**Committee of Experts on the Transport of Dangerous Goods  
and on the Globally Harmonized System of Classification  
and Labelling of Chemicals**

**Electric storage systems: sodium-ion batteries**

**Sodium ion batteries: Assignment of a dedicated UN number  
and related special provisions – corrections to document  
ST/SG/AC.10/C.3/2021/55**

**Transmitted by the expert from France**

**Figure 5.2.5: Lithium or sodium ion battery mark**

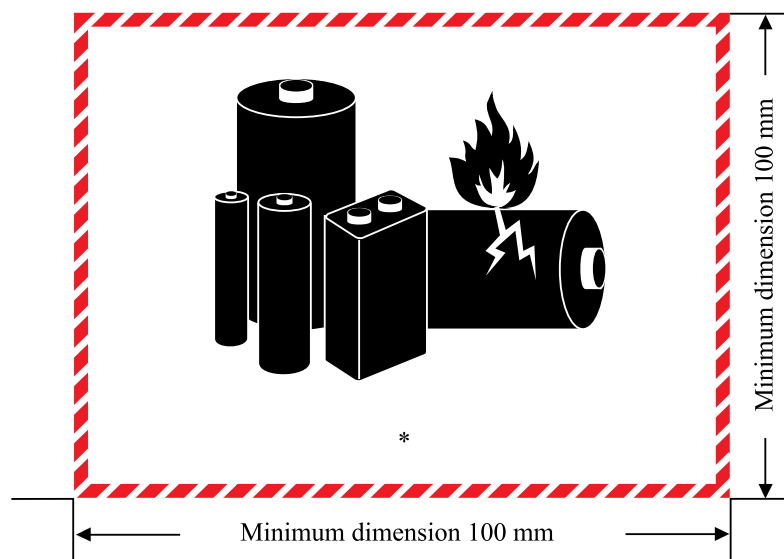
9 To allow appropriate hazard identification, the current “lithium battery mark” should be applicable to sodium ion batteries.

Amend 5.2.1.9 as follows:

“5.2.1.9 Lithium or sodium ion battery mark

5.2.1.9.1 Packages containing lithium or sodium ion cells or batteries prepared in accordance with special provision 188 shall be marked as shown in Figure 5.2.5.

5.2.1.9.2 The mark shall indicate the UN number, preceded by the letters “UN”, i.e. “UN 3090” for lithium metal cells or batteries, ~~or “UN 3480” for lithium ion cells or batteries,~~ or “UN XXXX” for sodium ion cells or batteries. Where the ~~lithium~~ cells or batteries are contained in, or packed with, equipment, the UN number, preceded by the letters “UN”, i.e. “UN 3091”, ~~or “UN 3481”~~ or “UN XXXY” as appropriate shall be indicated. Where a package contains ~~lithium~~ cells or batteries assigned to different UN numbers, all applicable UN numbers shall be indicated on one or more marks.

The mark shall be in the form of a rectangle or a square with hatched edging. The dimensions shall be a minimum of 100 mm wide × 100 mm high and the minimum width of the hatching shall be 5 mm. The symbol (group of batteries, one damaged and emitting flame, above the UN number(s) ~~for lithium ion or lithium metal batteries or cells~~) shall be black on white or suitable contrasting background. The hatching shall be red. If the size of the package so requires, the dimensions may be reduced to not less than 100 mm wide × 70 mm high. Where dimensions are not specified, all features shall be in approximate proportion to those shown.”
